Informal Document No. **GRSP-34-8**  
(34<sup>th</sup> GRSP, 8–12 December 2003,  
Agenda item B.1.5.)

**PROPOSAL FOR DRAFT AMENDMENTS TO REGULATION No. 44**

(Child restraints)

Transmitted by the Expert from France

**"Annex 164**

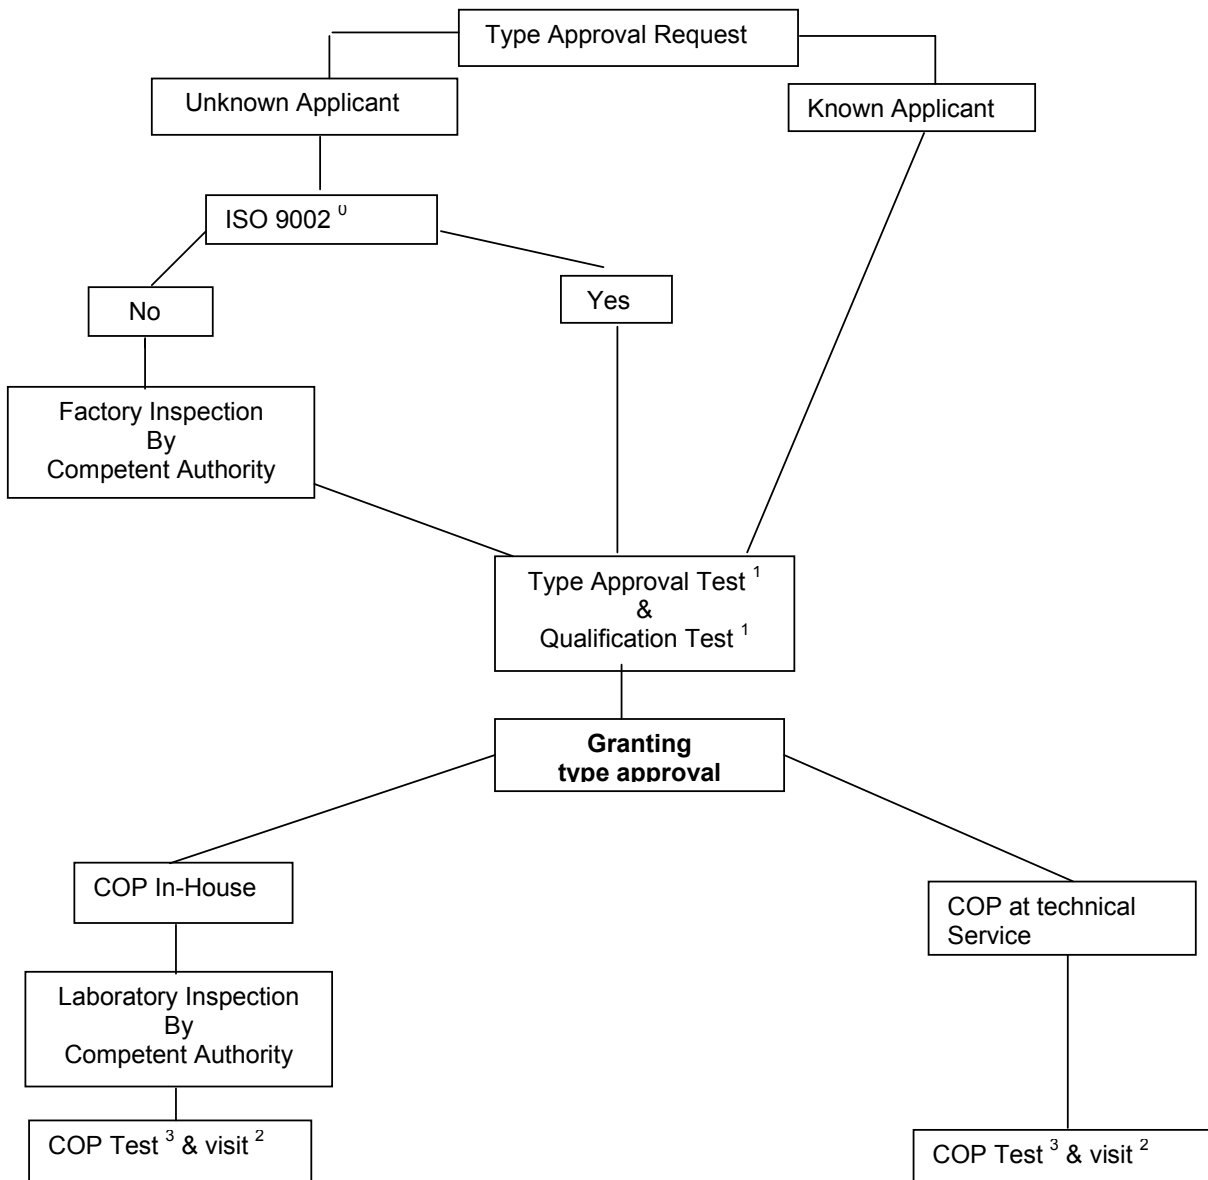
- 0) or an equivalent standard to this one
- 1) this tests have to be done at technical service
- 2) visit ~~of~~ to the manufacturer for inspection and random sampling by the Authority or technical service
  - a) if there is no ISO 9002: 32 times a year
  - b) if there is an ISO 9002: 1 times a year
- 3) tests in accordance ~~to 4.5.~~ with Annex 17 6
  - a) if there is no ISO 9002:
    - i. of the Authority or technical service during the visit of footnote 2a
    - ii. of the manufacturer between the visits of footnote 2b
  - b) if there is an ISO 9002: taken by the manufacturer, procedure checked during visit of footnote 2b.
